Access Compliance Report

Public Rights-of-Way

Intersection ID: 53713	Main Street: N_TRYON_ST	Cross Street: PERIWINKLE_HILL_AV	Location: S
ADA ID: 2E41FCB180DD	Ramp Type: BlendTrans2	Initial Pass/Fail: Pass	Overall Compliance: No
Severity Score: 5			
Codes/Mitigation Info/Possible Solution		Field Measurements/Component Compliance

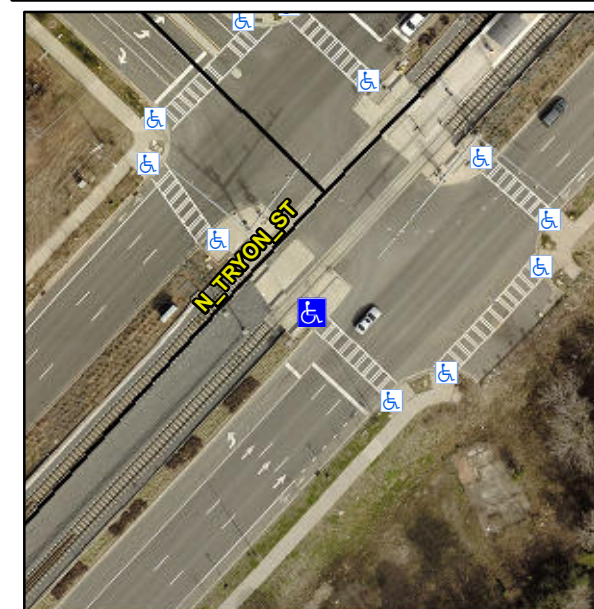
R304.2.3

Compliance	Description	Data	Compliance	Description	Data
N/A	Ramp Length (in)	102.0	Yes	BlendTrans Slope (%)	1.9
Yes	Ramp Width (in)	106.0	Yes	BlendTrans XSlope (%)	0.5
Yes	Flare Type	Curbed_NoWalkSurface	No	Flare Type	Curbed_WithWalkSurface
N/A	Flare Slope LT (%)	N/A	N/A	Flare Slope RT (%)	N/A
N/A	Flare Traversable LT?	No	N/A	Flare Traversable RT?	No
N/A	Landing Length (in)	N/A	Yes	DWS Provided?	Yes
N/A	Landing Width (in)	N/A	Yes	DWS Contrast?	Yes
N/A	Landing Slope (%)	N/A	Yes	DWS Length (in)	24.0
N/A	Landing X Slope (%)	N/A	Yes	DWS Full Width?	Yes
N/A	Landing Curb? (Y/N)	No	Yes	DWS Offset (in)	0.0
N/A	Shared Landing?	No			
Yes	Gutter Ponding?	No	Yes	Gutter Slope (%)	1.6
Yes	Gutter Lip Ht (in)	0.0	Yes	Gutter X Slope (%)	0.7
N/A	Painted X Walk1?	Yes	N/A	Painted X Walk2?	N/A
	X Walk 1 Direction	To SE		X Walk 2 Direction	N/A
	X Walk 1 Width (in)	106.0		X Walk 2 Width (in)	N/A
	X Walk 1 Slope (%)	1.5		X Walk 2 Slope (%)	N/A

Remove & Replace Curbed Edge.
